ELECTRONIC ASSEMBLY  
 CATALOG NO. 5701R4-160  
 AMPEX ELECTRIC CORPORATION  
 REDWOOD CITY, CALIFORNIA

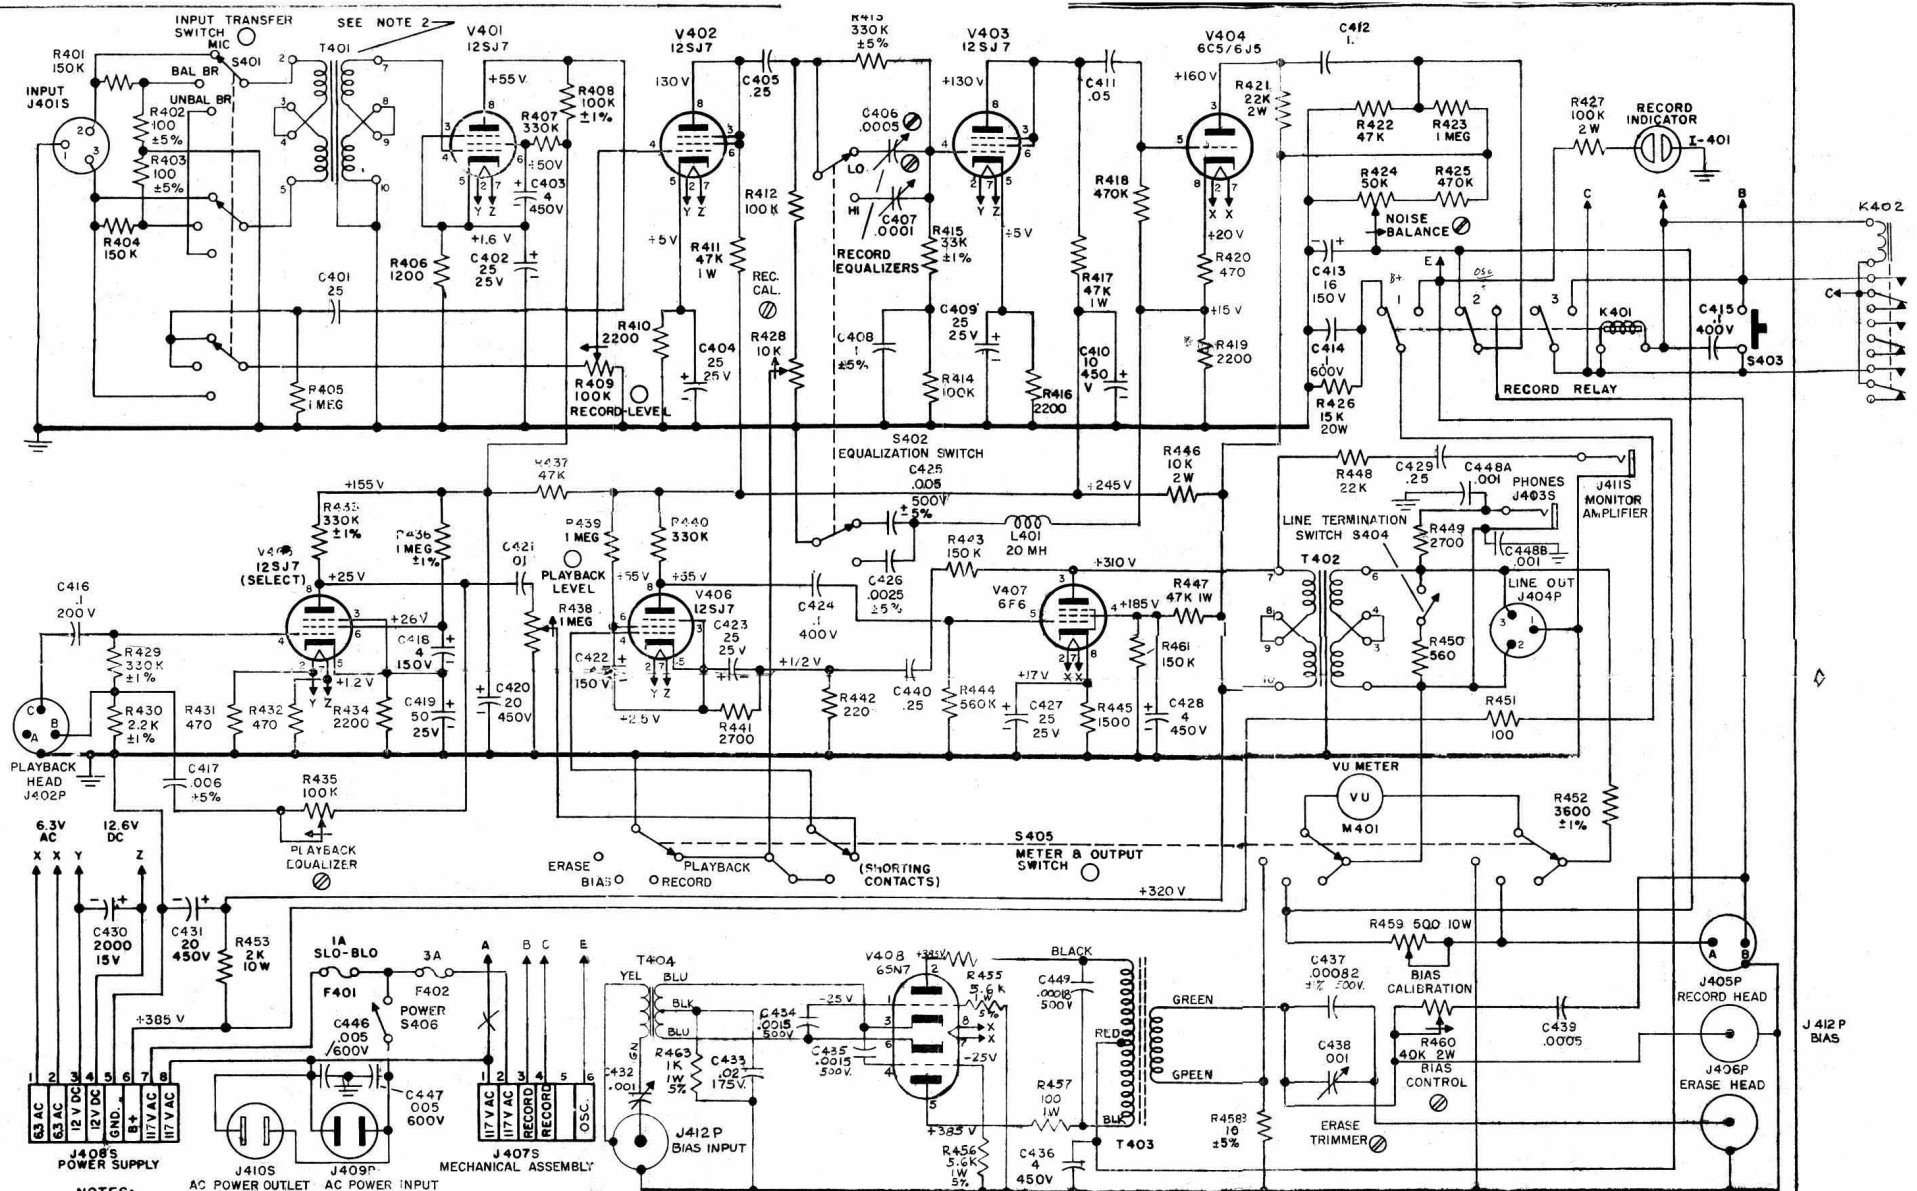
SCHEM. REF.*	OLD PART NO.	OLD VALUE	NEW PART NO.	NEW VALUE	SCHEM. REF. NO.	OLD PART NO.	OLD VALUE	NEW PART NO.	NEW VALUE
C-432	034-05B	.0004 5%	038-008	.001	C-437	034-101	.00056 5%	034-067	.0009 .50% 1%
C-433	034-081	.004 5%	035-020	.02	R-458	043-227	7.5 5%	041-095	10 5%
C-434	034-081	.004 5%	034-021	.0015	K-402				
C-435	034-058	.0004 5%	034-021	.0015	T-404			B-30044-10	
C-449			034-005	.00015 5%					
R-455	041-06B	47K	041-279	5.6K 1W 5%					
R-456	041-06B	47K	041-279	3.6K 1W 5%					
R-463			041-102	1K 1W 5%
